SUBJECT: CATAWBA NUCLEAR STATION, UNIT 2 RE: ISSUANCE OF AMENDMENT  
(TAC NO. MB1498)

SAFETY EVALUATION BY THE OFFICE OF NUCLEAR REACTOR REGULATION  
RELATED TO AMENDMENT NO. 186 TO FACILITY OPERATING LICENSE NPF-52

CATAWBA NUCLEAR STATION, UNIT 2

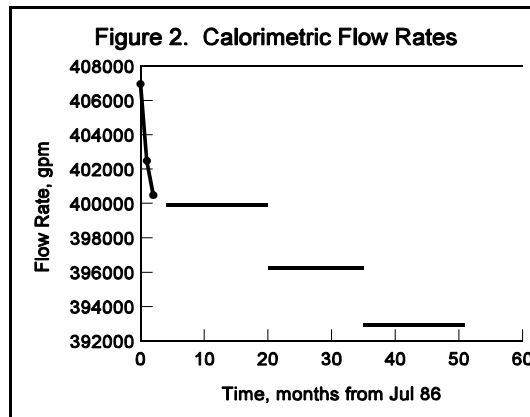
To assess these statements and their implications, we first assume the initial flow rate degradation is due to RCP impeller smoothing, as discussed in Section 3.2, below. Then we assume the later degradations are essentially due to physical changes during refueling outages and flow rate is essentially unchanged between outages. (This assumption is consistent with observed behavior.) This results in the Figure 2 representation of the early values.

licensee's model predicts this has little effect on RCS flow rate, which substantiates our judgement that SG tube plugging has little influence on flow rate during the first few months of operation. Since SG tube plugging does not significantly affect the flow behavior illustrated in Figure 2, we conclude that the apparent step flow rate decrease of 3700 gpm at 20 months is due to a combination of core reload and RTD bypass removal.

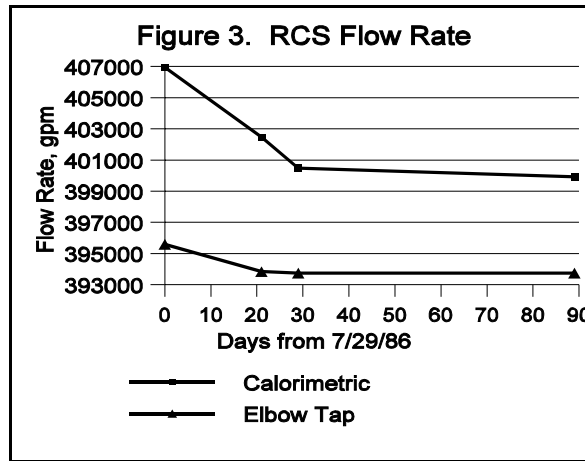
We believe these statements are correct after an initial wear-in period. However, we do not agree for the first few months of operation. Our conclusion is substantiated by Reference 9, where the leading edge flow meter (LEFM) indicated an early flow rate decrease of 0.6 to 0.8 percent, by reported observation of similar flow rate decreases at several 3-loop and 4-loop plants, and by a close examination of the licensee's data, as discussed in the following paragraphs.

Consider the flow rate degradation illustrated in Figure 3, which provides the early calorimetric values and elbow predictions.<sup>3</sup> The calorimetric values reflect the downward trend illustrated in Figure 1, but the elbow values are constant after the initial value. (We are interested in the trend in elbow values, not the values for purposes of this discussion since the elbow information results from coefficients obtained using 11 calorimetrics.) Neglecting potential error due to uncertainty in the values and a bias due to using 11 calorimetrics, the change in elbow value during the first 21 days of operation is about 1750 gpm, a change we believe is due to RCP impeller smoothing, as identified in Section 2, above. Further, the elbow information implies there was little smoothing after 21 days. Since some impeller smoothing will have occurred before the Figure 3 information was obtained, on this basis the total smoothing effect will be greater than 1750 gpm.

Although the first calorimetric was made at 75 percent power, we note the trend is consistent with the second and third values and there is little inconsistency between the calorimetric and elbow trends, although the magnitudes are different. If we assume the calorimetric values are correct, then the flow rate decreases by 6500 gpm during the first month and, consistent with the calorimetric, is relatively constant during the next few months.

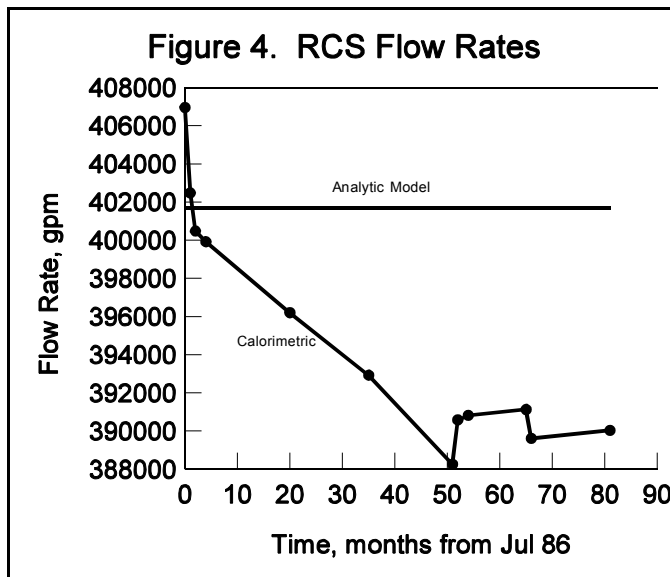
As illustrated in Figure 4 (References 2 and 5), the analytic model predicts an essentially constant RCS flow rate of ~401,700 gpm during the first few years of operation in contrast to the calorimetric determinations, which show significant variation.

There were 80 SG tubes plugged early in plant operation. The licensee's model predicts this has little effect on RCS flow rate, a reasonable prediction. However, the licensee did not address modeling changes associated with RTD bypass removal, and its model results do not reproduce the flow rate increase illustrated by the elbow response following manifold removal and as-expected from that removal. The licensee should ensure the model correctly represents these flow perturbations.

We have no information regarding pump history that underlies the RCP developed-head information provided to us in Reference 4, Table 6. Lacking such information, we will assume the tested pump or pumps were not operated for the extended time necessary to complete impeller smoothing. Consequently, we assume the analytic model uses "as-new" RCP flow characteristics. Since the analytic model predicted 401,700 gpm and the impeller smoothing effect appears to have been about 2000 to 4000 gpm, we conclude the analytic model should have predicted 399,700 to 397,700 gpm if it accounted for impeller smoothing. The greater value is essentially in agreement with the 400,000 gpm calorimetric value. The larger assumed impeller smoothing impact would mean the model underpredicted flow rate by about 2000 gpm.
